**SHEARON HARRIS NUCLEAR POWER PLANT, UNITS 2 AND 3
DOCKET NOS. 52-022 AND 52-023
SUPPLEMENT 2 TO RESPONSE TO REQUEST FOR ADDITIONAL INFORMATION
REGARDING THE ENVIRONMENTAL REVIEW**

**Shearon Harris Nuclear Power Plant Units 2 and 3
Supplement 2 to Response to NRC Request for Additional Information Regarding the
Environmental Review, dated November 13, 2008**

NRC RAI #: 4.3.1-2

NRC RAI #: 9.4-1

Potentially Disturbed Areas
 Attachment 4.3.1-2A,
 Figure 1

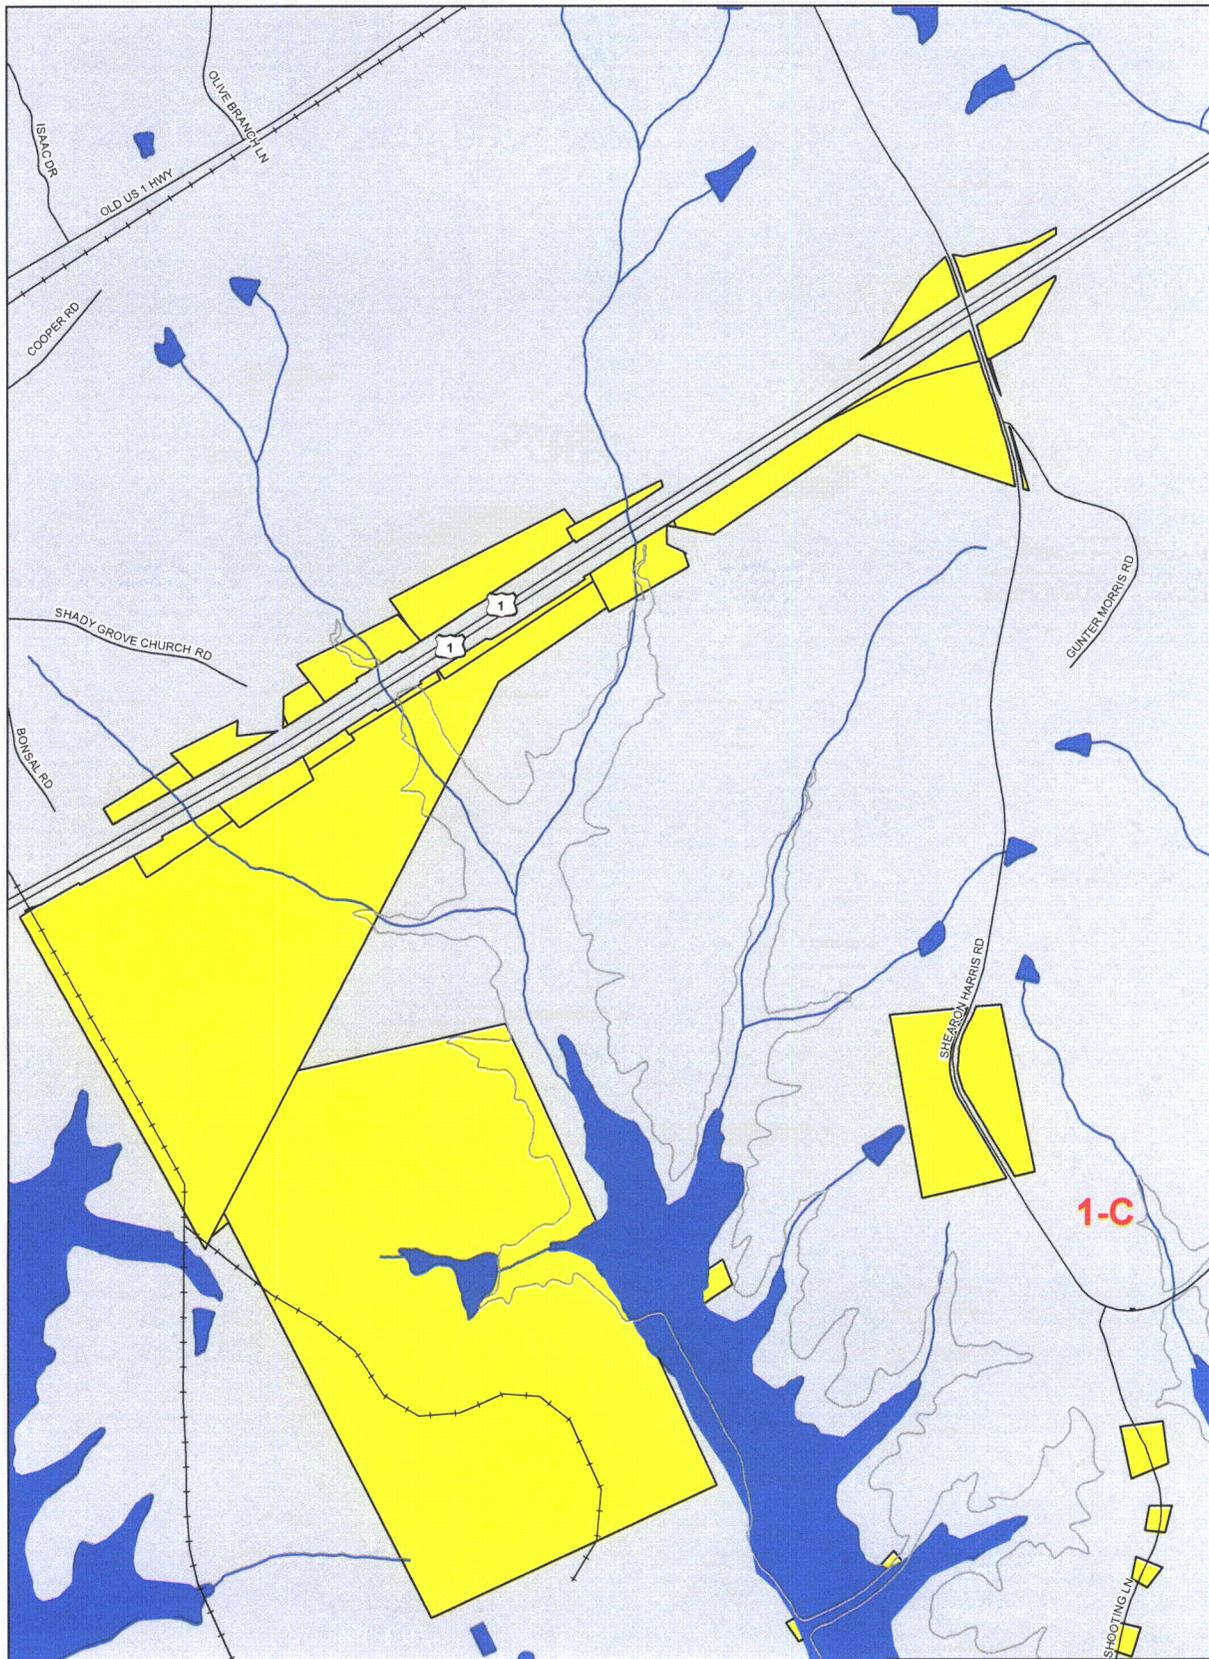
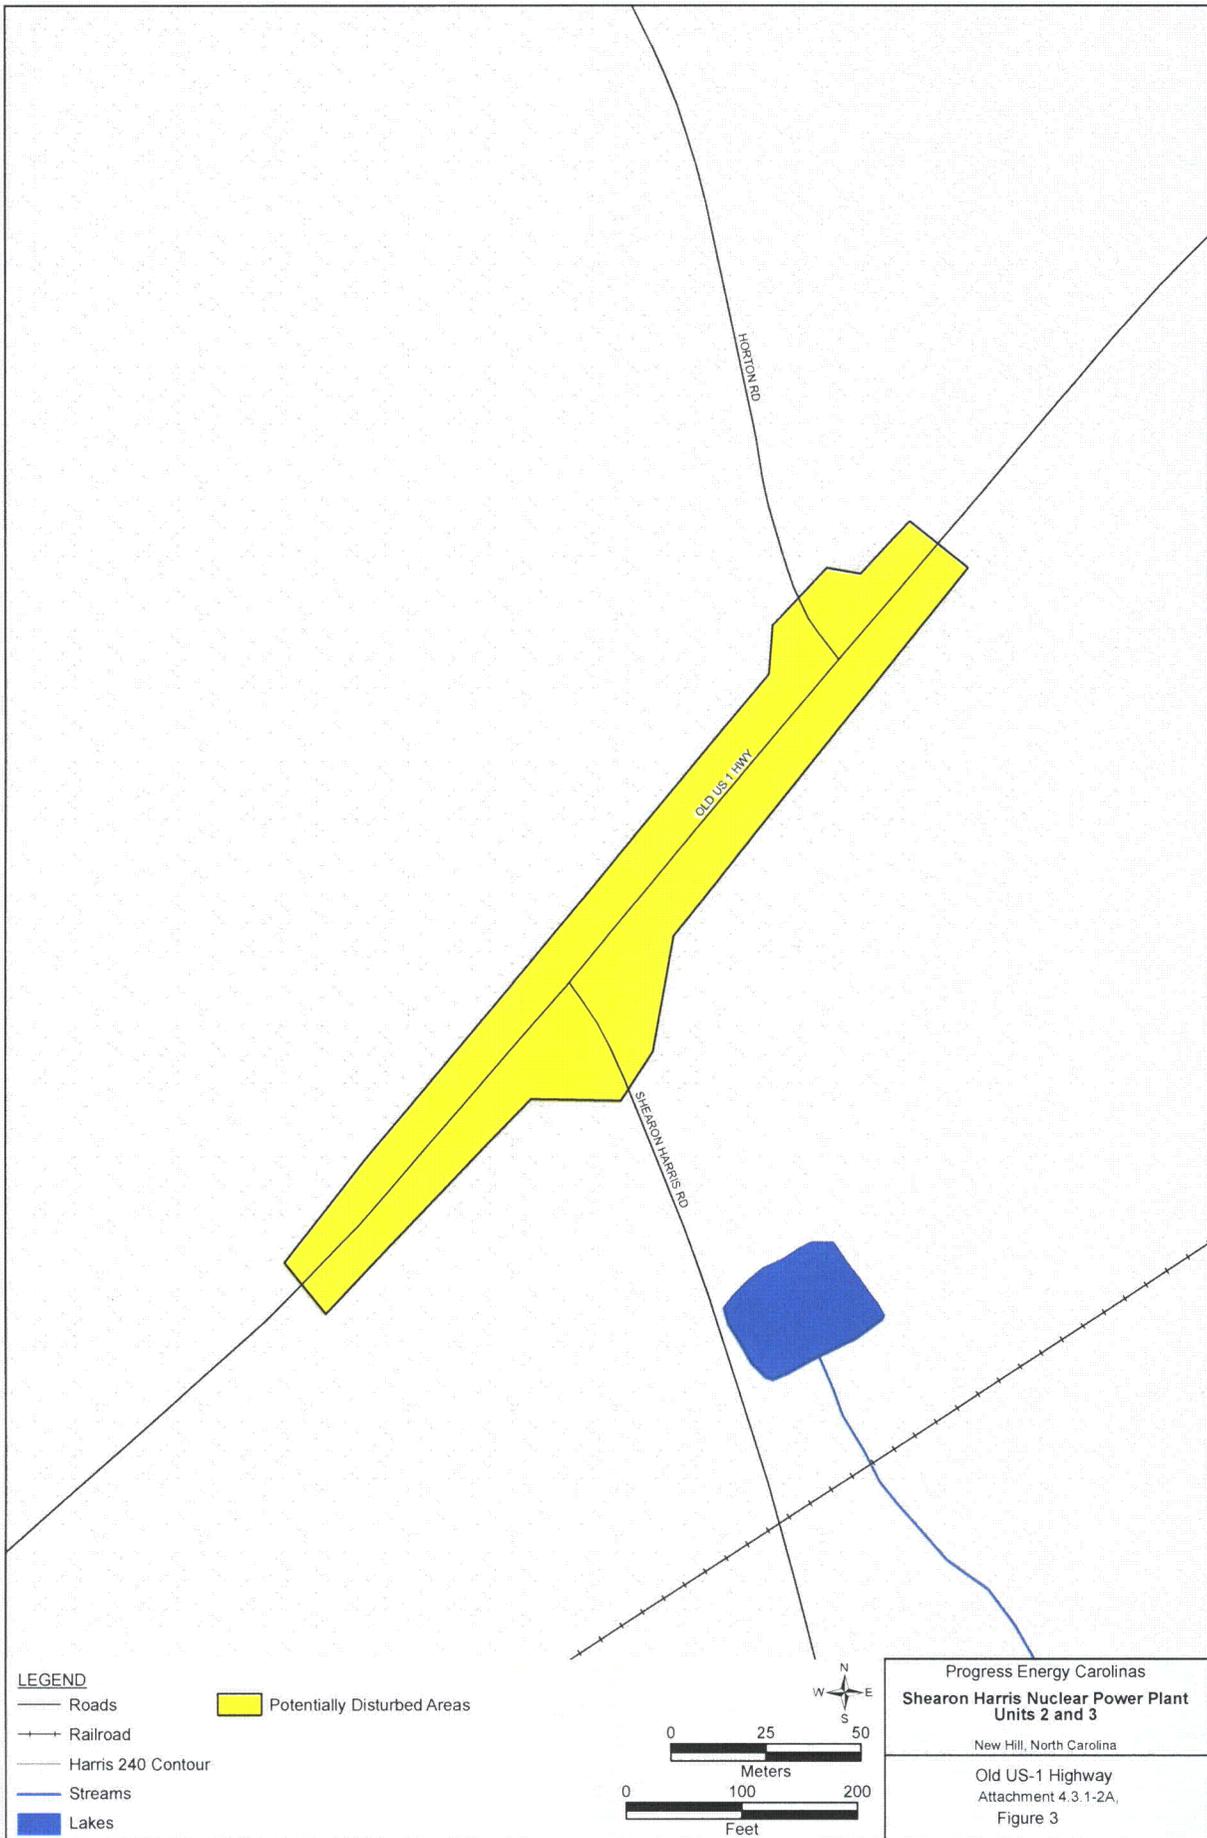
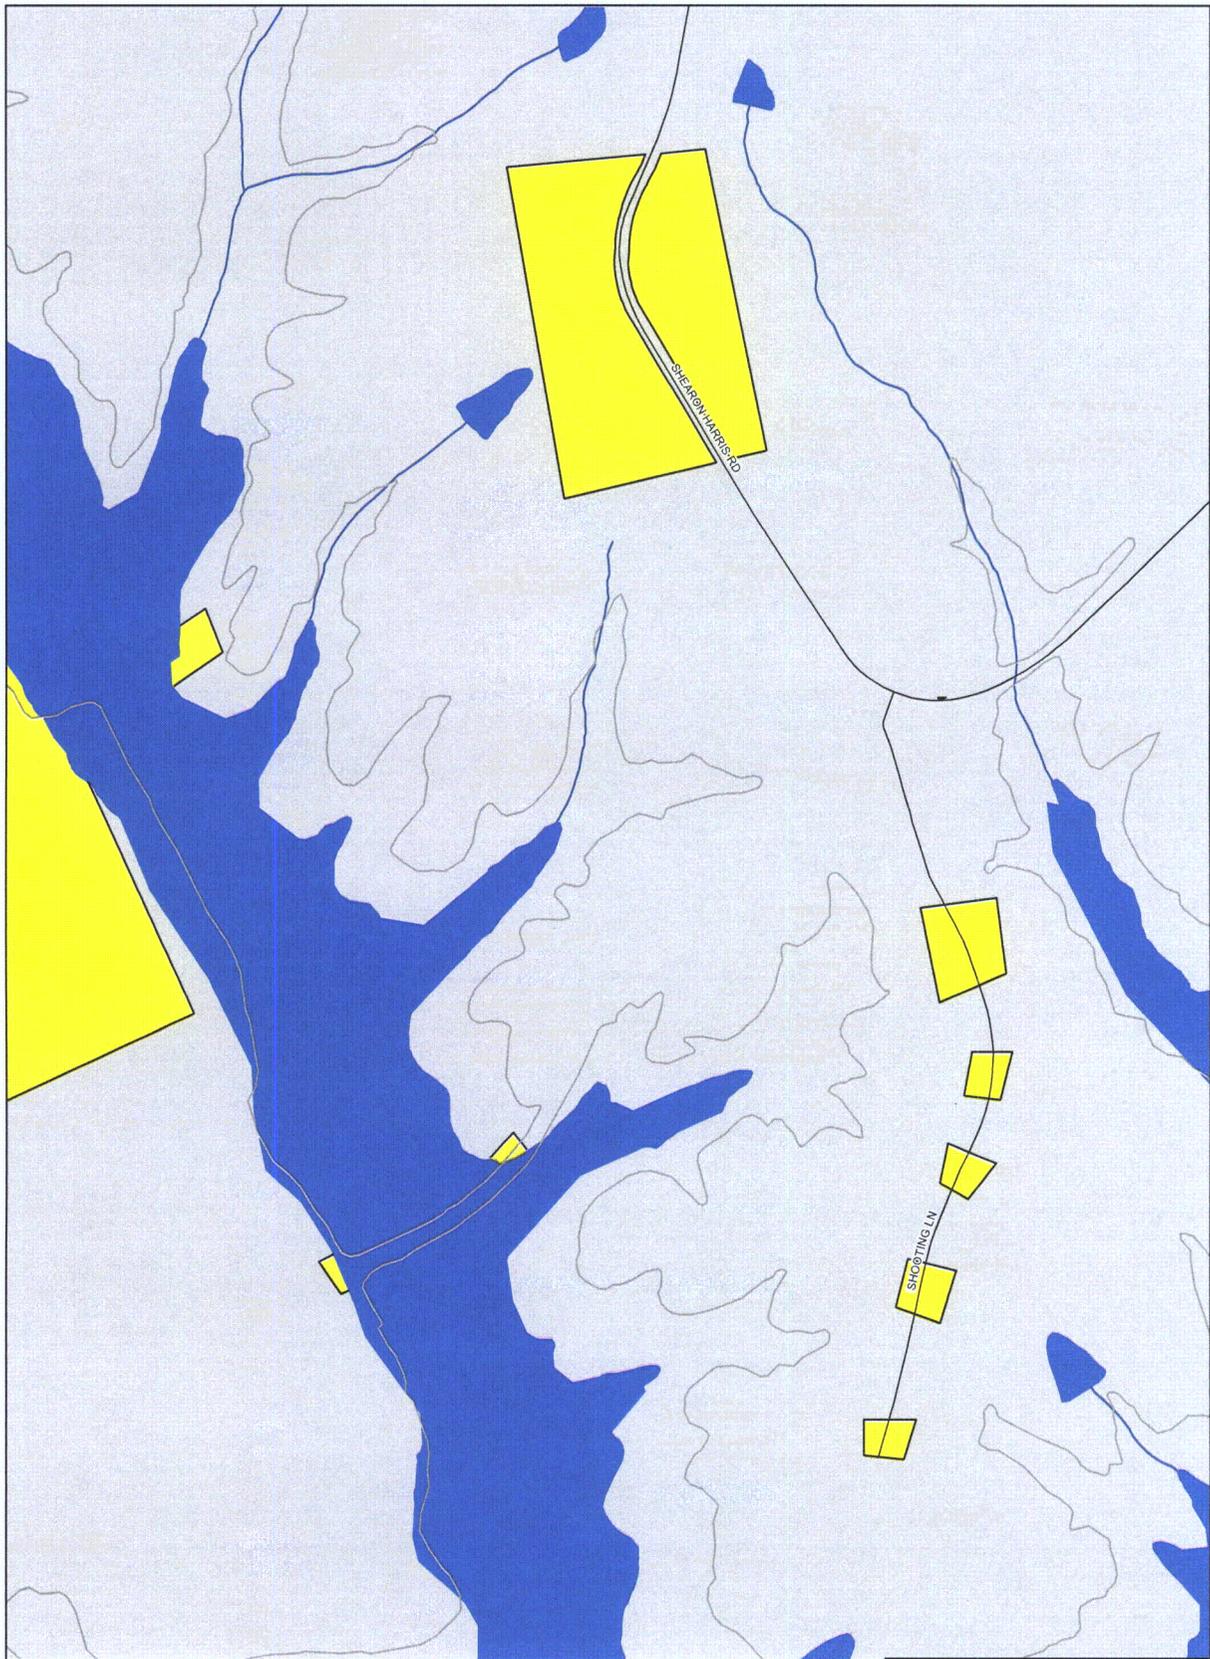
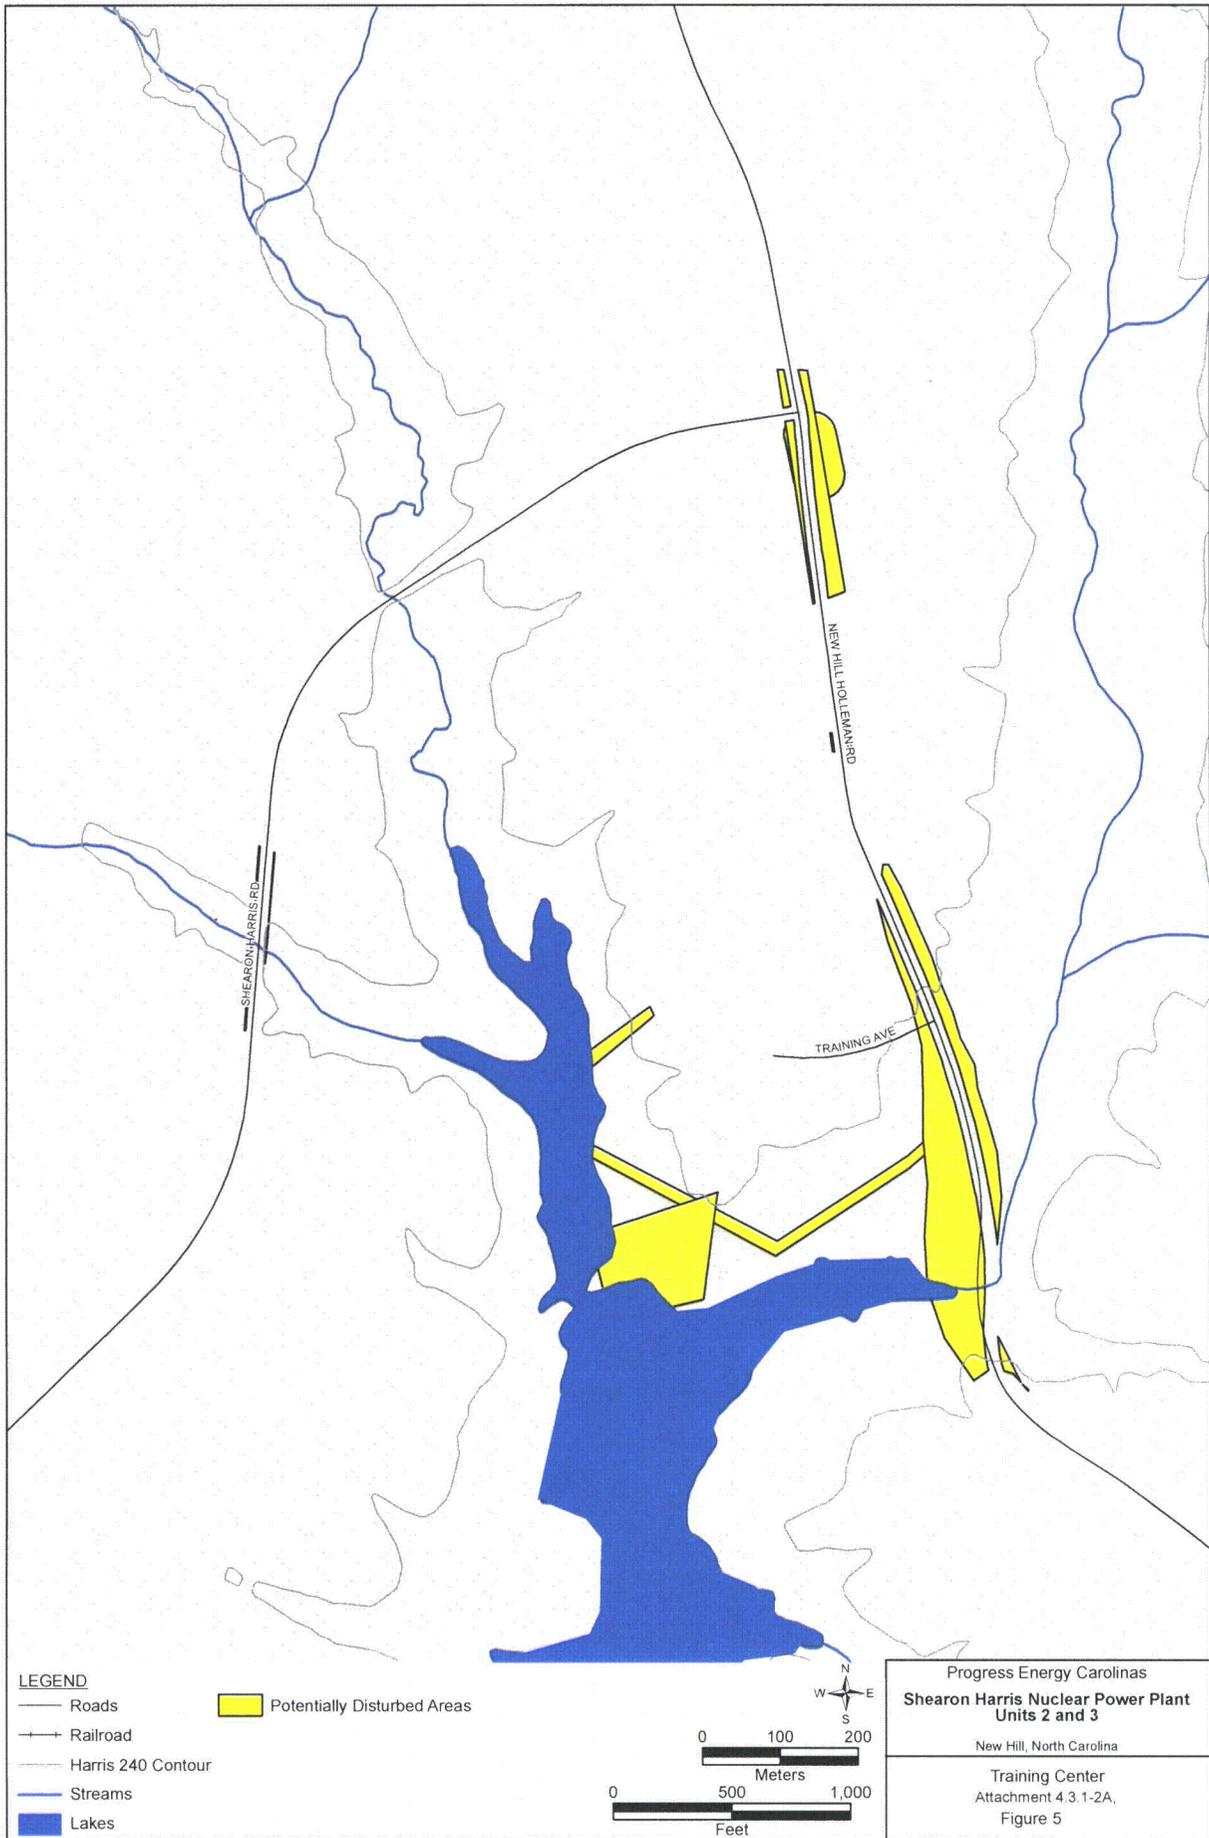
Confirm the locations of various proposed construction project areas and activities and provide information from the most recent terrestrial and wetland surveys of areas that will be impacted during construction.

Also provide RFI-158 CH2M Hill or most current plan and design – for depiction of temporary construction areas.

Discussions held at the site audit indicated that there may be changes to the proposed locations of various construction activities and construction materials sites and/or that some construction and roadway improvement areas have not been surveyed to characterize the resources. Please provide information and figures describing the proposed locations of temporary construction and laydown areas. Provide recent survey data for wetlands and terrestrial habitats, including wildlife and plants that may be impacted by both temporary and permanent construction not addressed in the ER, including but not limited to: temporary laydown areas for unit 3, construction parking areas, cooling tower locations for units 2 and 3, Wastewater Treatment Plant (WWTP) and any expanded WWTP lines, and any roadway improvement or construction projects outside the 220 to 240 contour around the reservoir. Provide the number of acres to be affected and the dominant habitat types for each area.

Potentially disturbed areas related to temporary and permanent construction, including temporary laydown areas for HAR 3, construction parking areas, cooling tower locations for HAR 2 and HAR 3, wastewater treatment plant (WWTP), any expanded WWTP lines, and any roadway improvement or construction projects outside the 220-ft. to 240-ft. contour around the reservoir, are shown in Attachment 4.3.1-2A. This set of figures was developed based on the information included in RFI-158, as well as available subsequent information regarding construction plans.
